In the drawings

Remarks

To understand these amendments, it is helpful to understand the invention. The invention improves windmill performance by providing multiple sets of three windmill blades attached to one another and mounted to a single hub. The hub can be provided with multiple plates to mount groups of blades.

FIG. 2

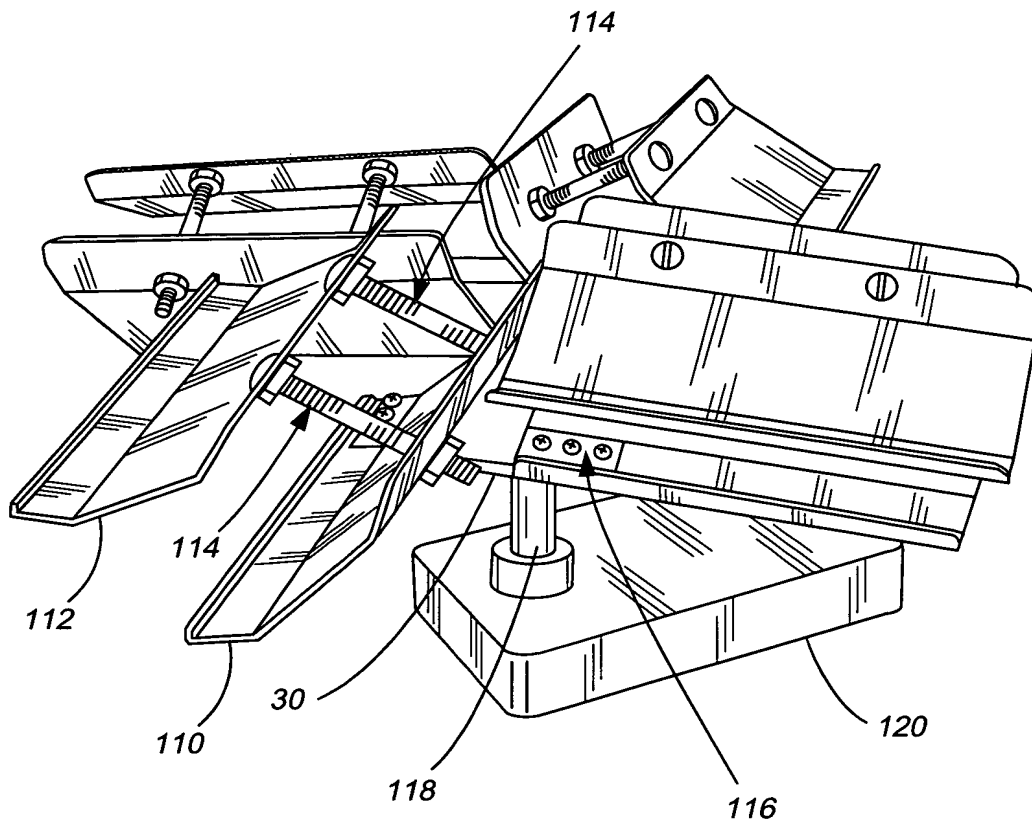
In particular, Figure 2 has been amended to show part numbers; which have been inserted on page 7 of the specification.

FIG.3

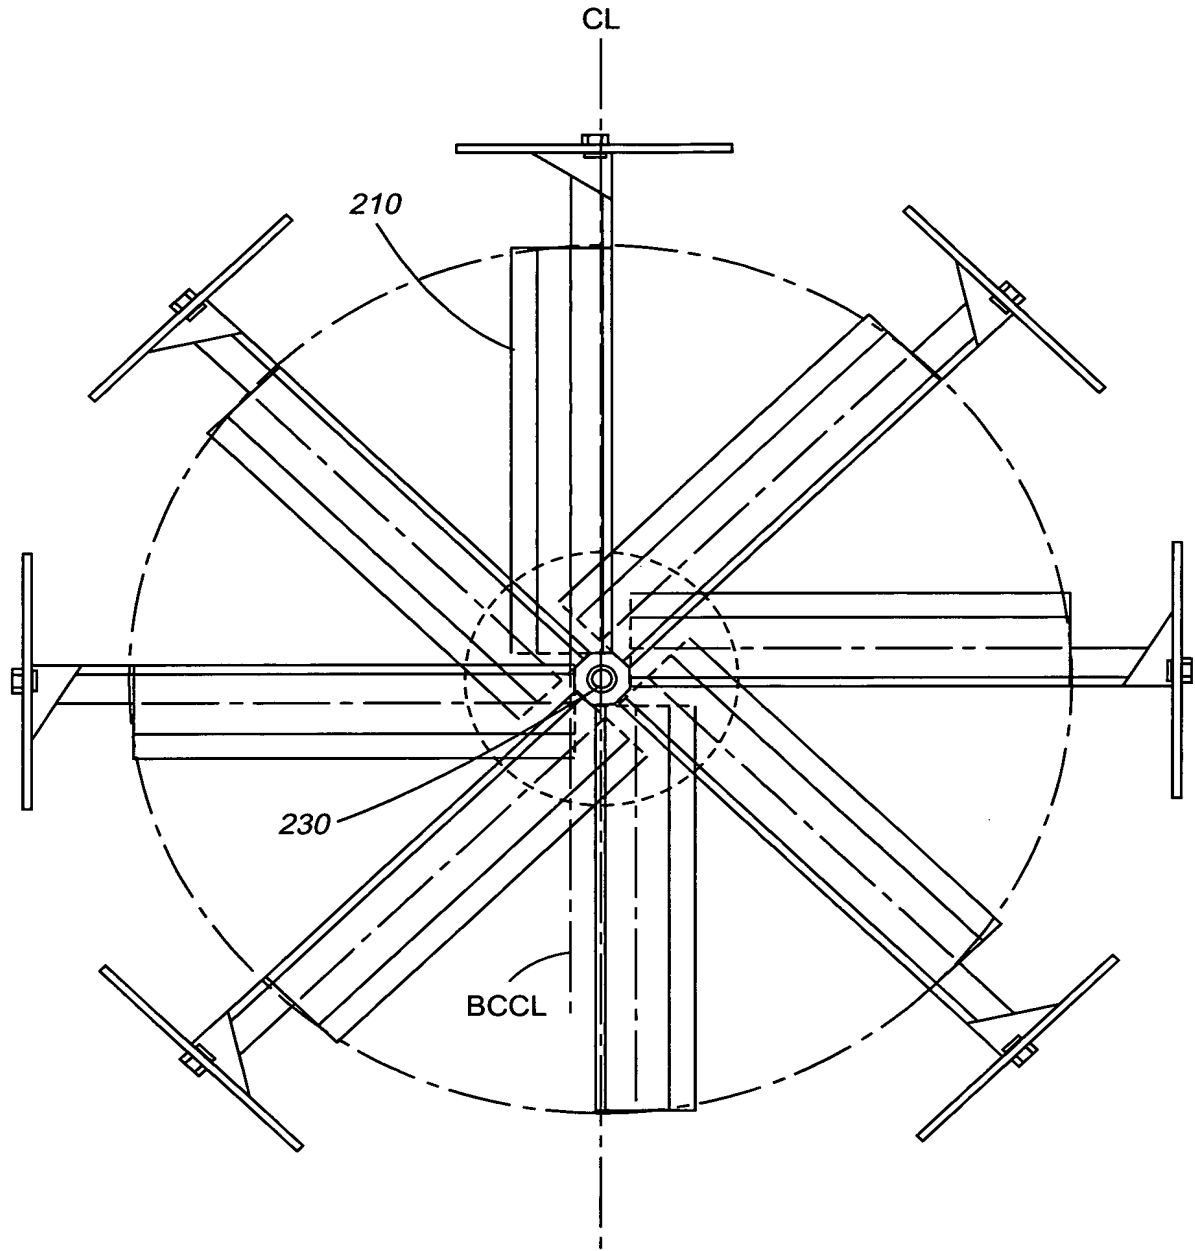
Figure 3 has been amended to show part numbers and center lines. A description has been inserted on page 8 of the specification.

FIG. 13

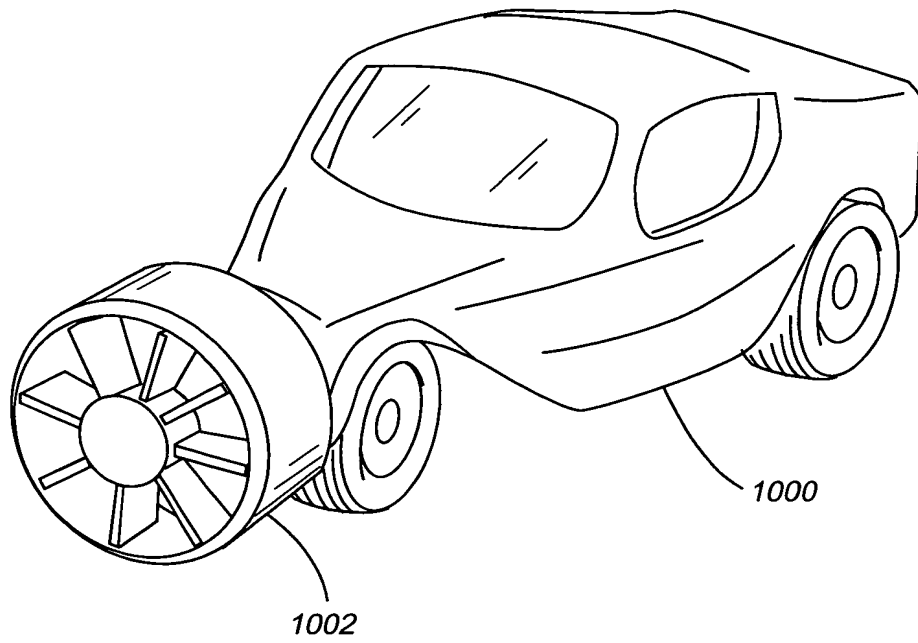
Figure 13 has been amended to show part numbers; which have been inserted on page 10 of the specification.
